ADDENDUM NO. 5

Warren Central High School Addition and Renovation - Phase 3
9500 E. 16th Street
Indianapolis, IN 46229

ADDENDUM NO: 5

PROJECT NO: 2021056

WALL SECTIONS
3/A403 & 4/A403

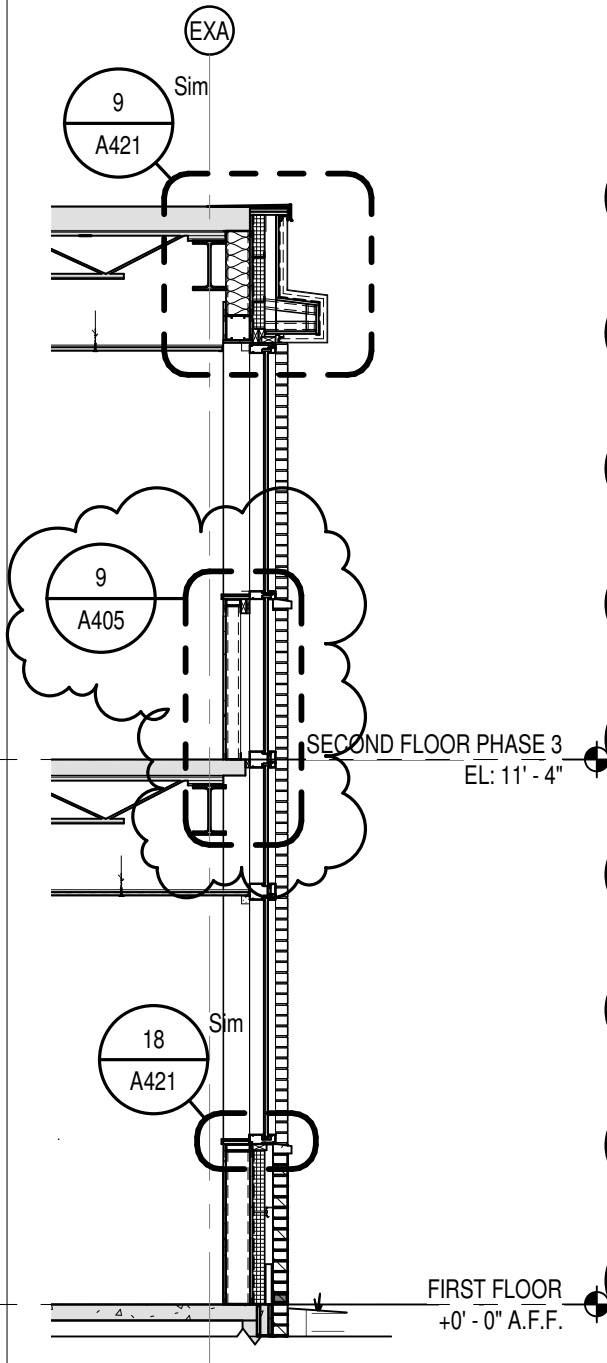
- A. At Wall Sections 3/A403 and 4/A403, ADD Detail Annotation as indicated on attached supplemental drawing ADD5 – SD1.

SECTION DETAIL
9/A405

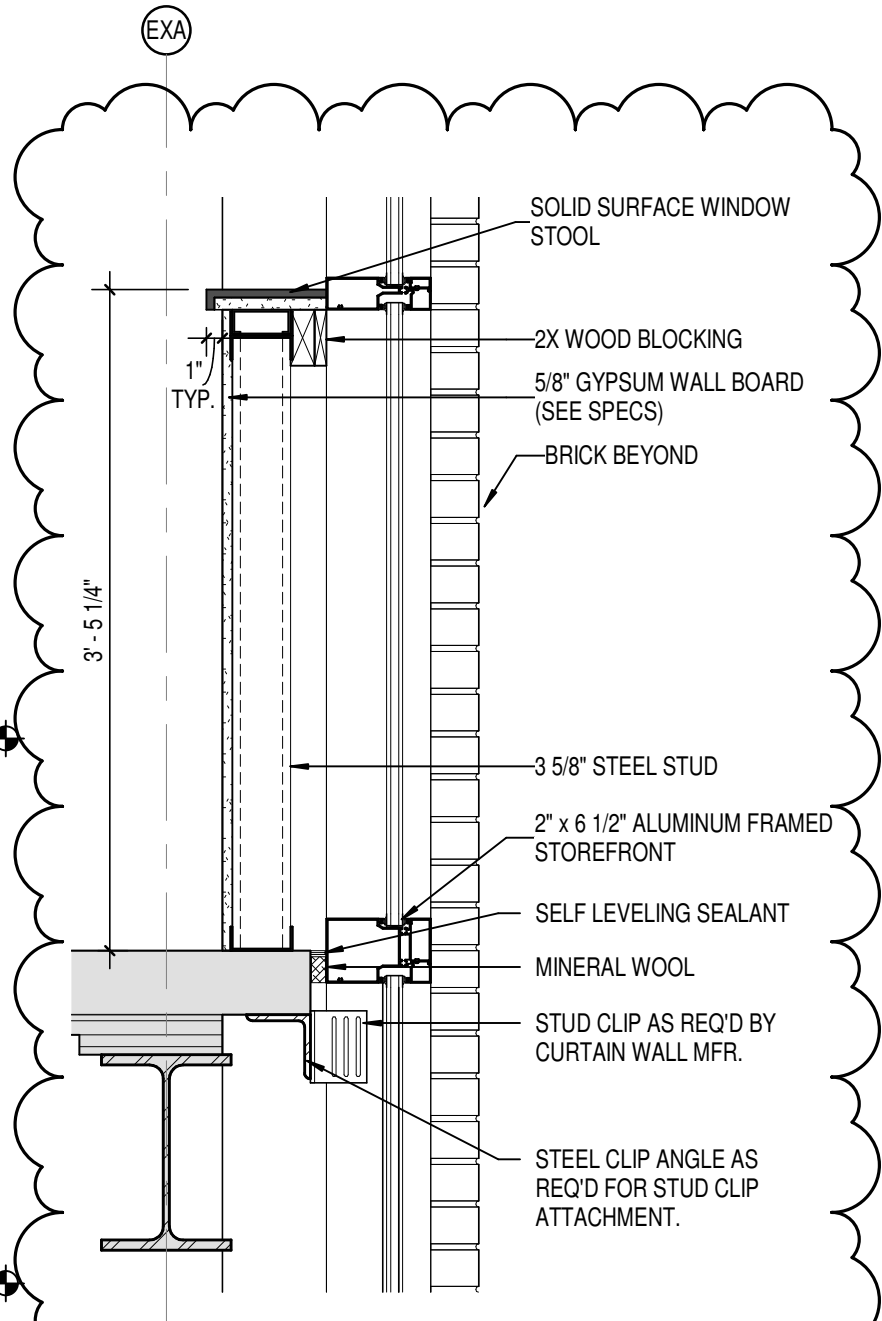
4. The Bid Category No. 5 Contractor shall be responsible for provision and installation of any clips, metal angles, or other attachment devices required to connect the curtainwall/storefront system to the existing building structure, including but not limited to those indicated in section 9/A405. Any fasteners, connections or blocking required by the curtainwall/storefront system manufacturer not indicated in the architectural details shall be provided by Bid Category No. 5.

- A. ADD detail section 9/A405 as indicated on attached supplemental drawing ADD5 – SD1.
